WEST SHORE SKATE SPOT COMMUNITY SURVEY

SUMMARY OF FEEDBACK

Posting Period of Community Survey: March 4th – 23rd, 2022

KEY CHANGES TO PROPOSED SKATE SPOT CONCEPT IN RESPONSE TO COMMUNITY FEEDBACK

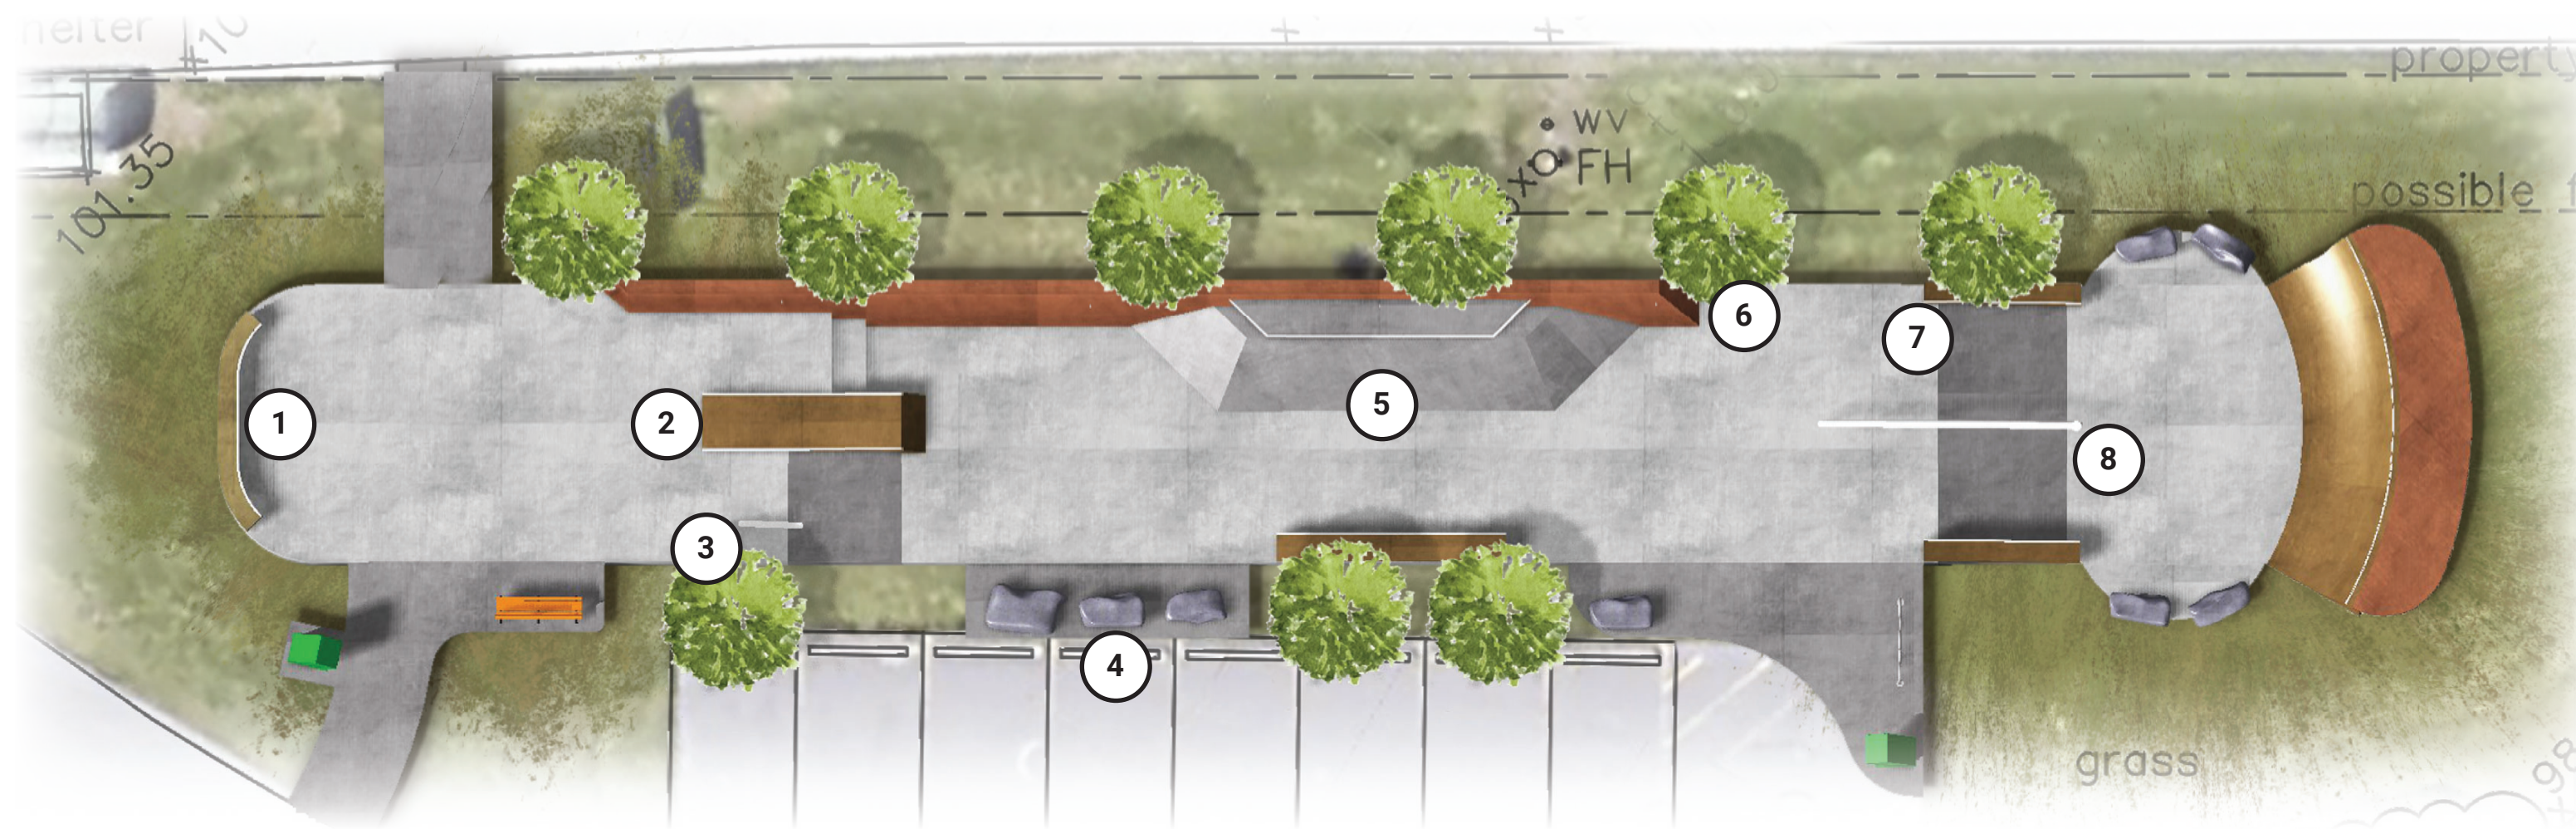
Notably, participants also provided many interesting and thoughtful comments in response to the preliminary concept, which ranged from detailed ideas for modifying features to additional site elements for passive use. To address the community's comments and preferences for the proposed skate spot features outlined above, the following key changes were made to the skate spot concept:

Can the curved entry benches / long slappy curb-to-wall be replaced?

Can the skate spot include more public seating?

1. Removed one curved entry bench and modified position to improve run-up
2. Shifted the pier 7 style manual pad to create a low ledge option from the bank
3. Moved pole jam to less prominent location
4. Introducing armour stone along southern edge to provide barrier / additional seating
5. Removed bench and steep china bank feature to extend bank to prioritize the hips and bank-to-ledge features
6. Added another hubba to provide frontside and backside option for both stances
7. Ended barrier wall earlier to provide space for a hubba
8. Added a handrail feature down the bank

While these features have been designed to be highly skateable, they are also included to serve additional purposes. The curved entry benches are intended to provide skate spot users with a place to take a break or socialize, as well as to place their belongings within clear view. The slappy curb-to-wall is intended to provide a physical barrier between the skate spot and adjacent Bayly Street. So, although these obstacles have not been removed from the revised concept for these reasons, the design / build team has modified them in response to community feedback, as shown above.

Yes, as indicated above in the revised concept, additional public seating has been included.
